September 3, 2025

Residence at Carter Lake – New Senior Living Facility – JGR Proj 25-3489

ADDENDUM NO. 1

D TYPICAL KITCHEN #01
CASEWORK ELEVATION
3/8"=1'-0"

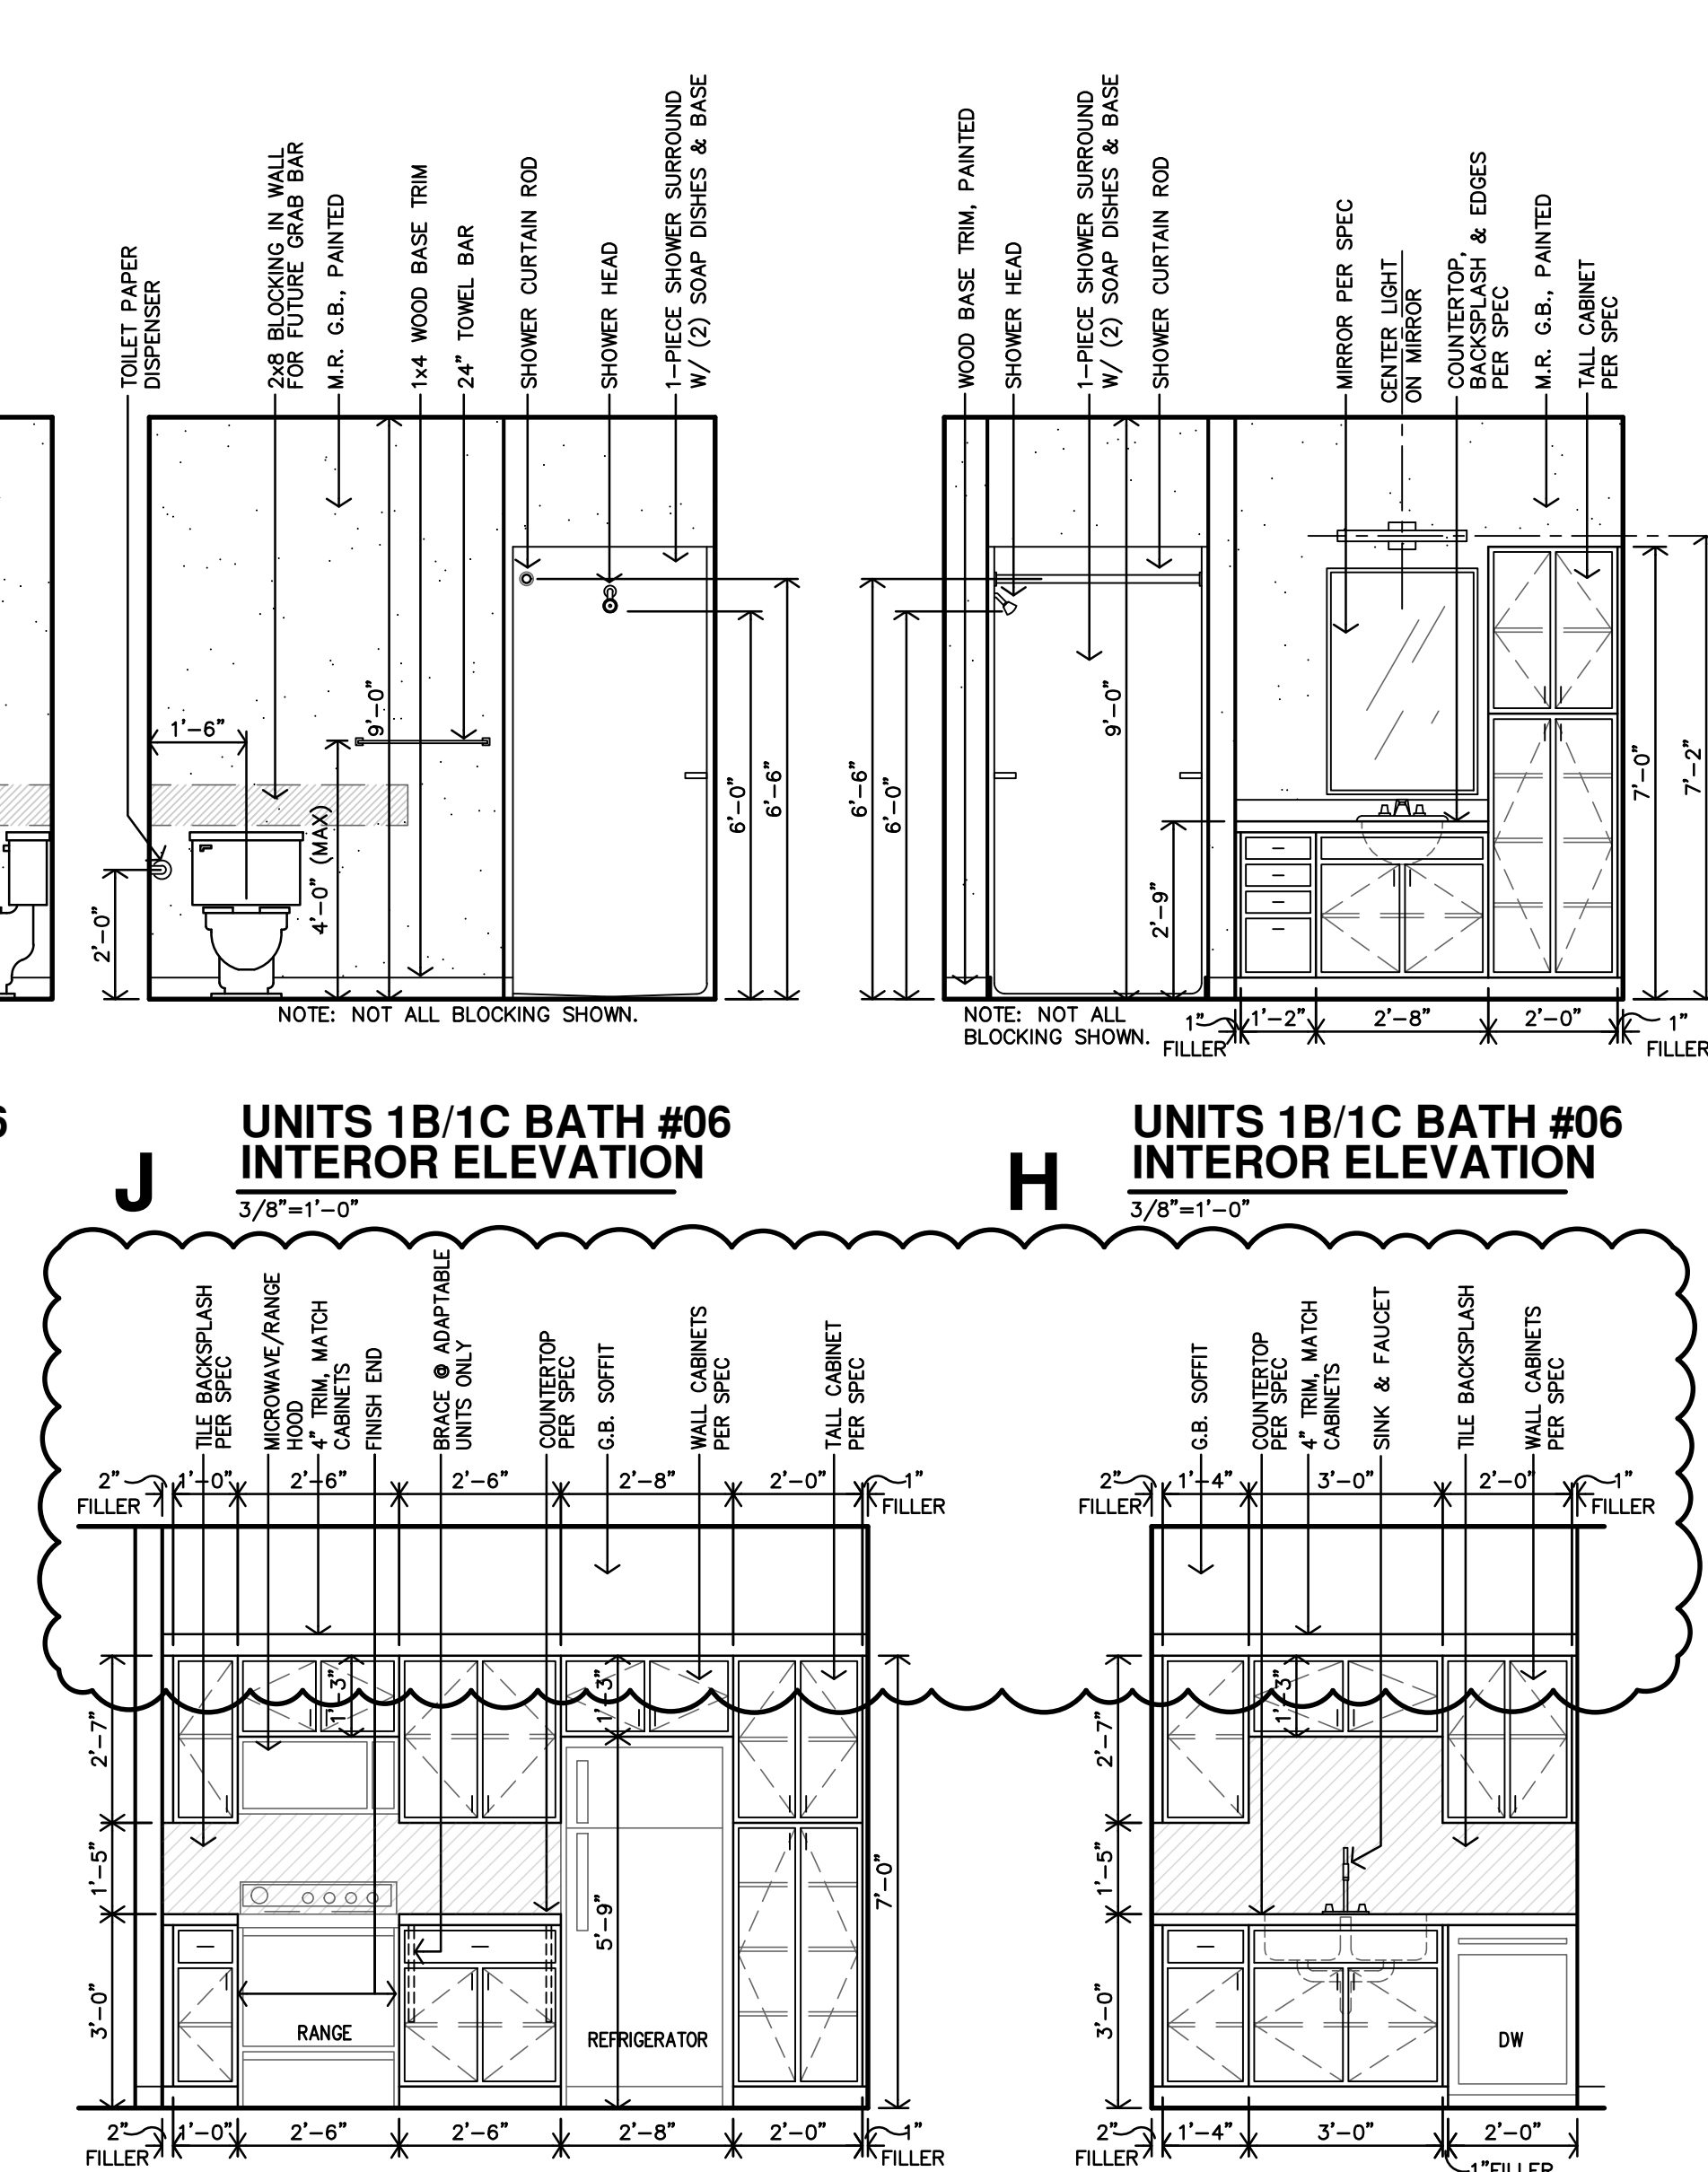
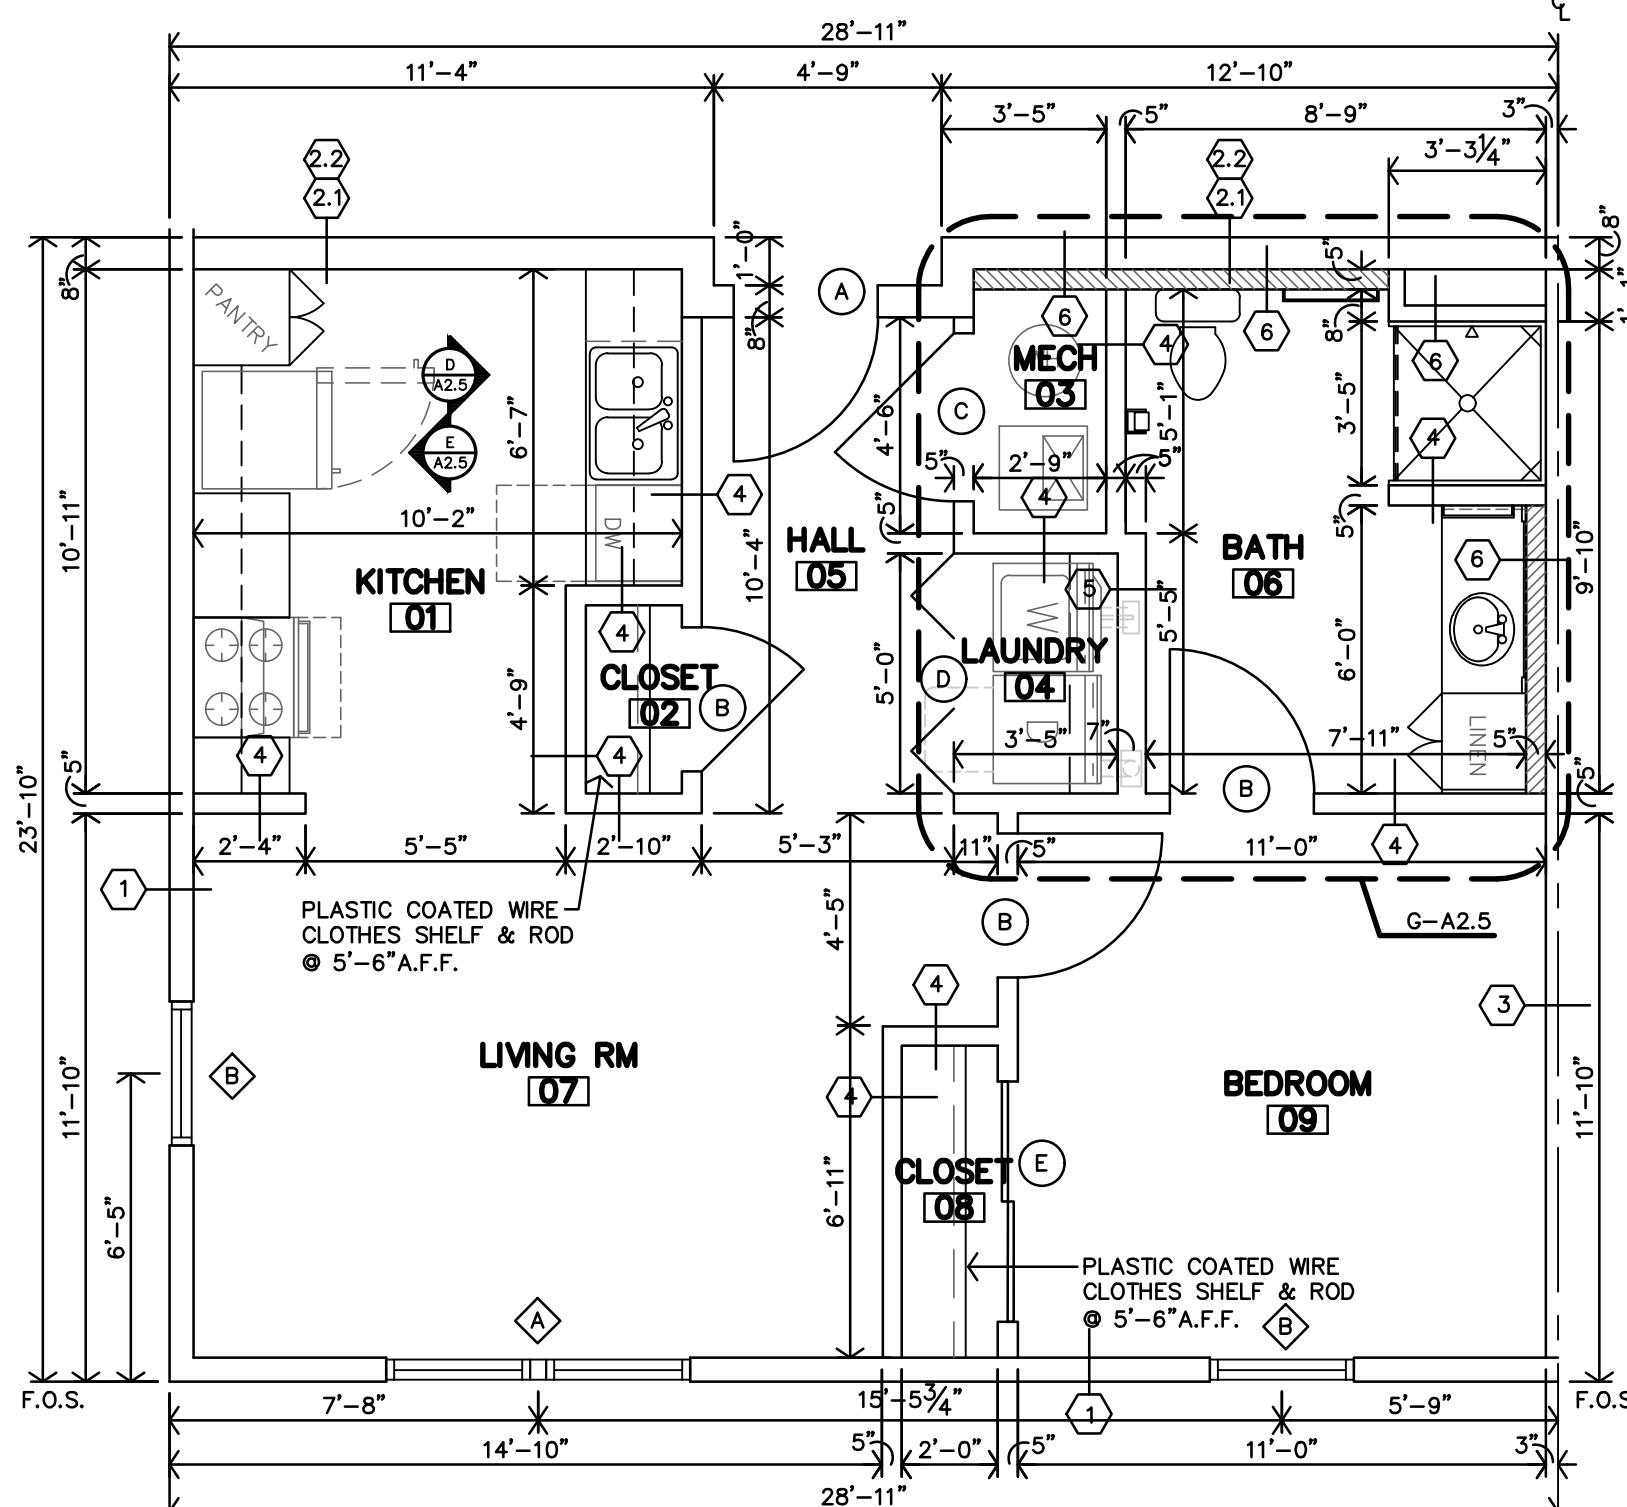
- c. Legend – Note 'E' has been added.
2. Sheet A2.3 – Detail B - Elevation call-out on Mezzanine 223 has been changed to J-A9.2
3. Sheet A2.5 – Details D & E – 4" wood trim and gyp. board soffit has been added above the upper cabinets.

H **CORRIDOR #225 (SOUTH) INTERIOR ELEVATION**
1/8"=1'-0"

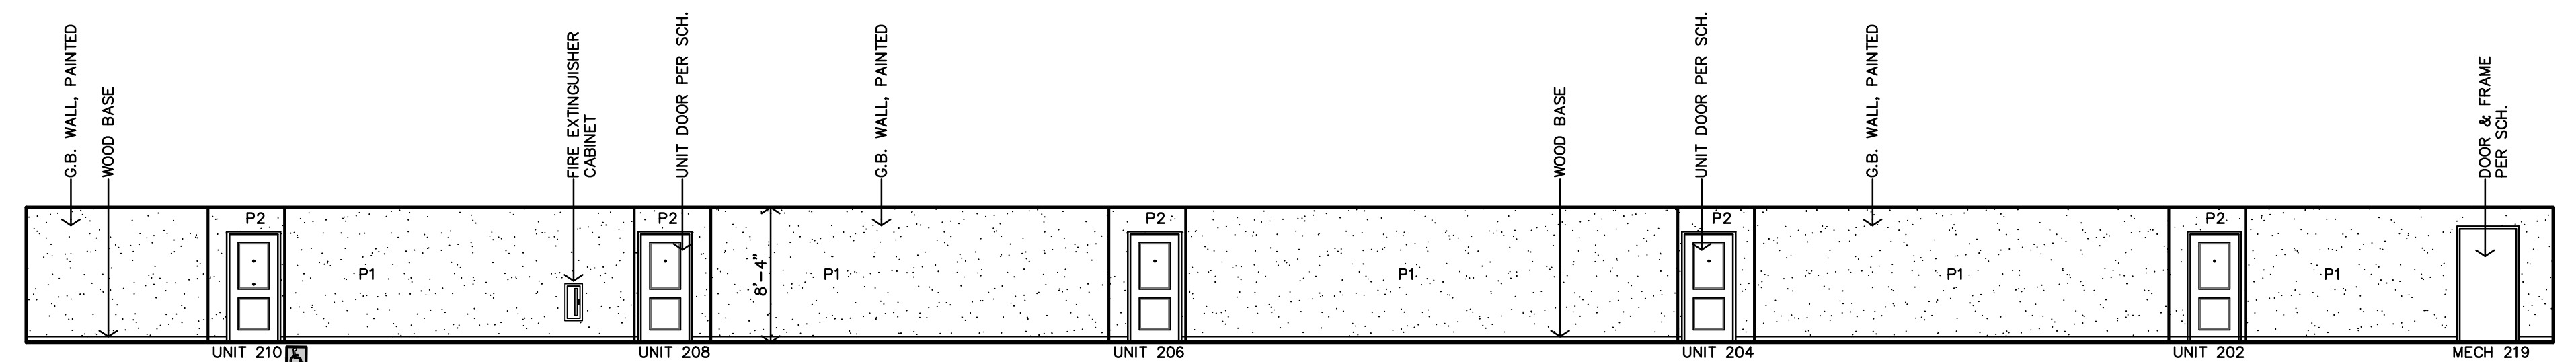
- c. Detail D – Ceramic tile above kitchenette has been deleted. Wood trim & molding have been added above the kitchenette and at the mezzanine.
 - d. Details G & H – Wood trim & molding have been added around and above the mailboxes.

M1.1

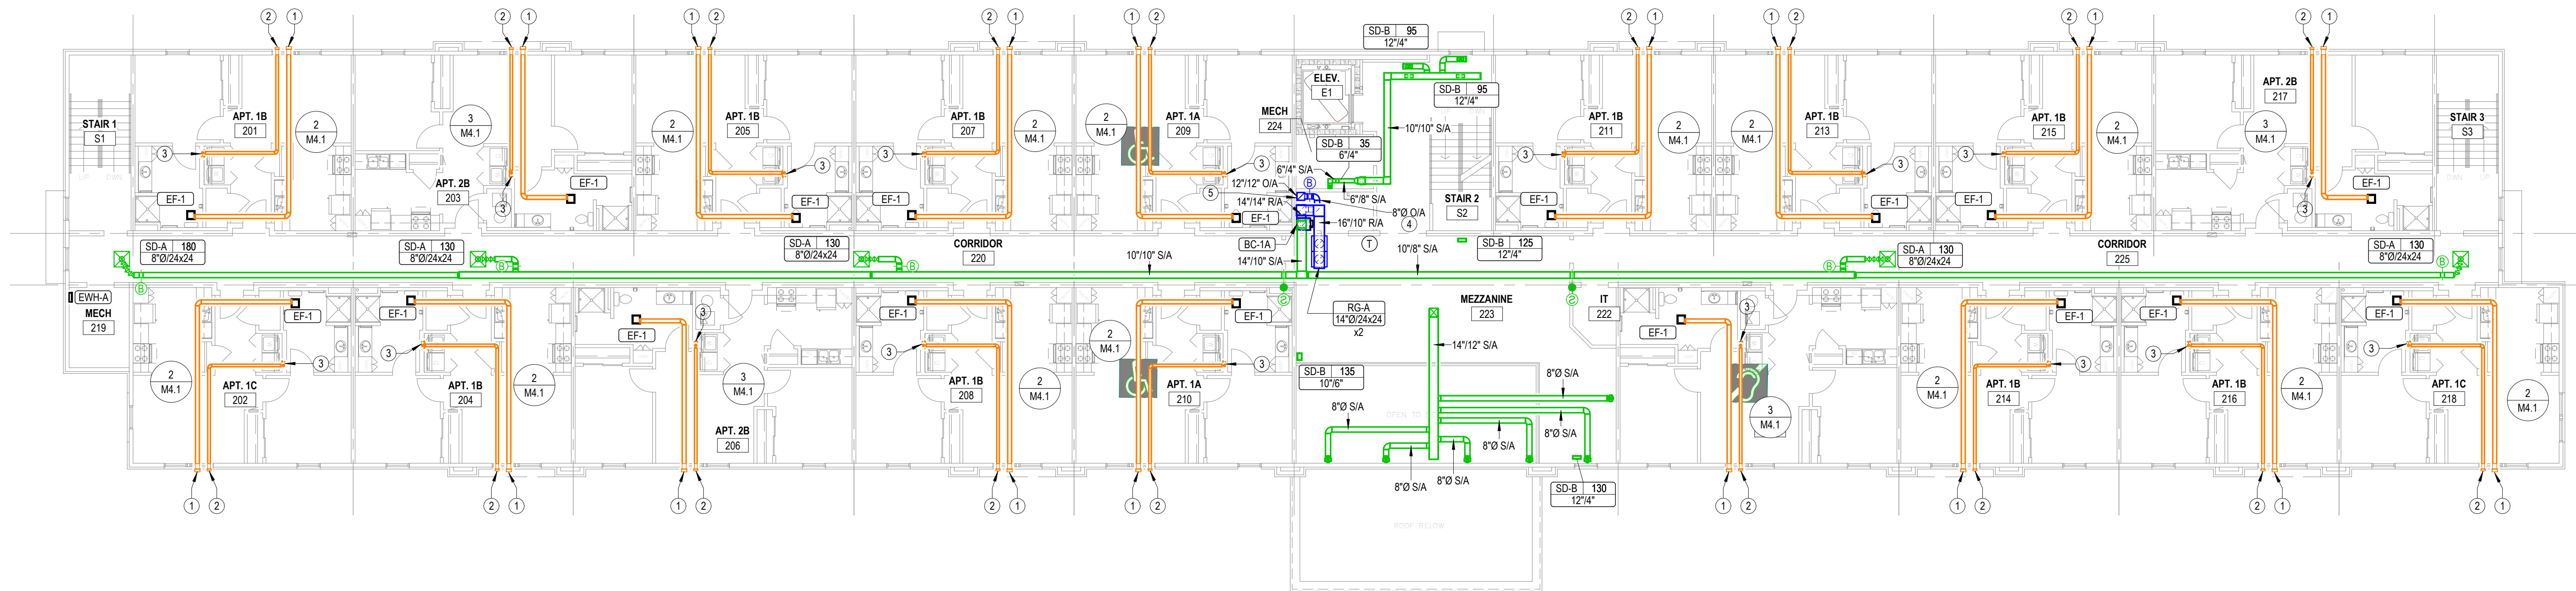
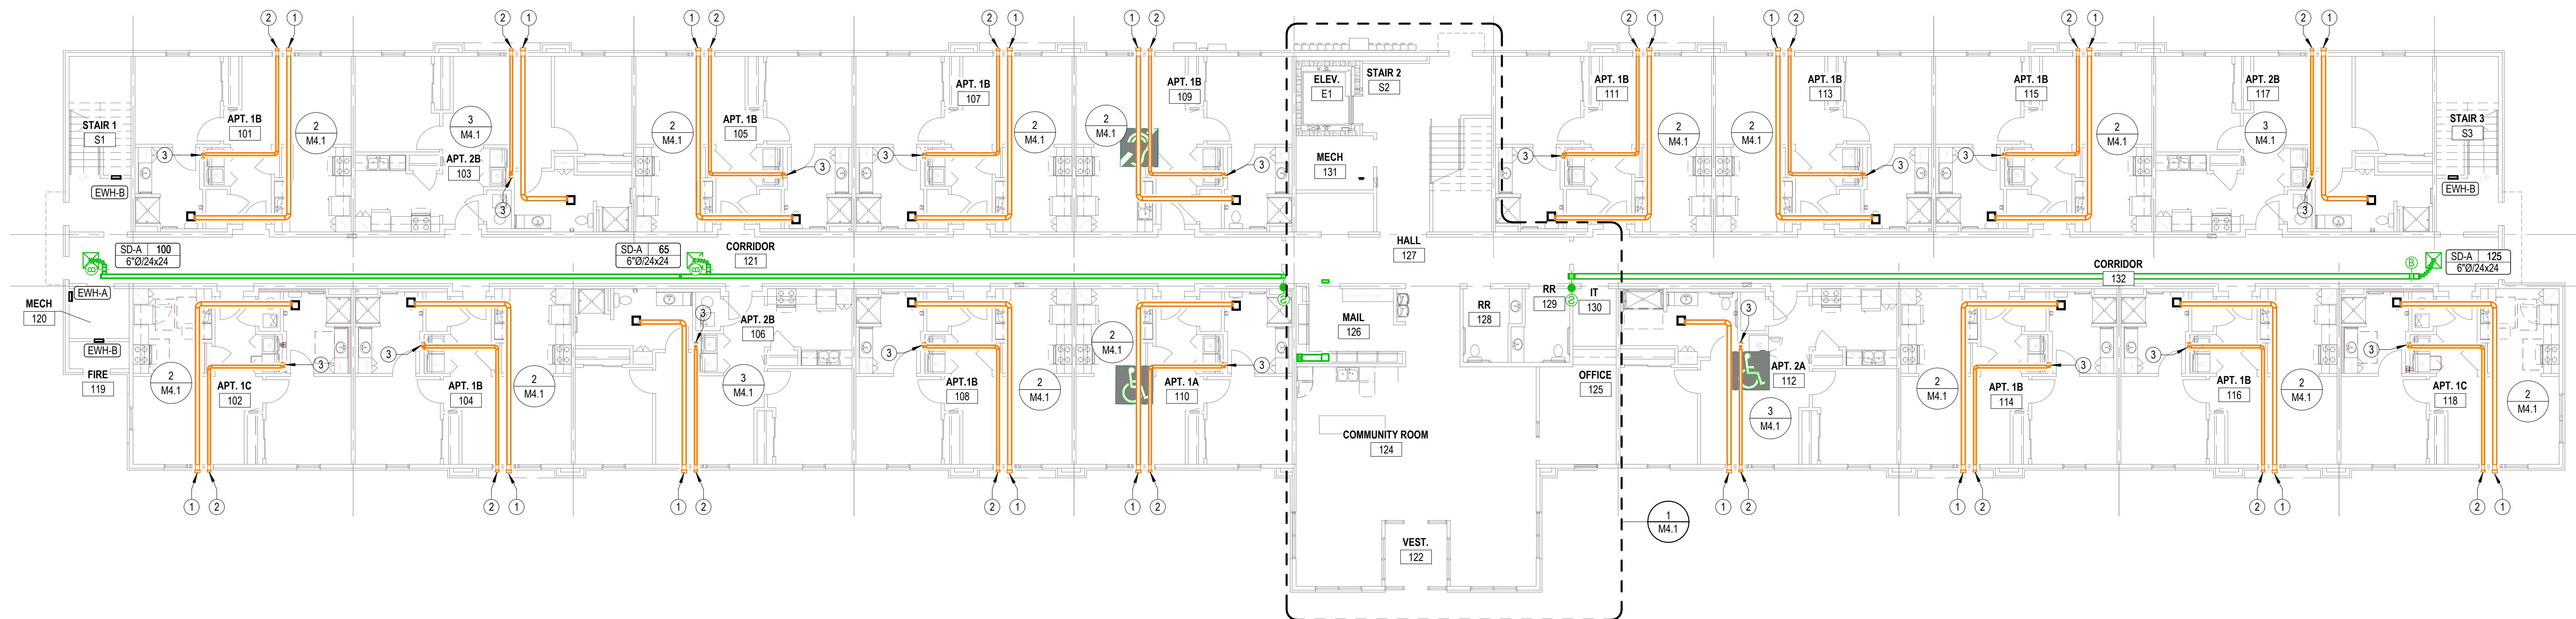
1. Sheets M1.1 & M1.2 – Modified note of OA duct to be routed in shaft and to utilize fire dampers where duct penetrates shaft.

- ROUTE O.A. DUCT DOWN THROUGH RATED SHAFT, PROVIDE FIRE DAMPER AT EACH LEVEL WHERE O.A. BRANCH DUCT PENETRATES SHAFT WALL.
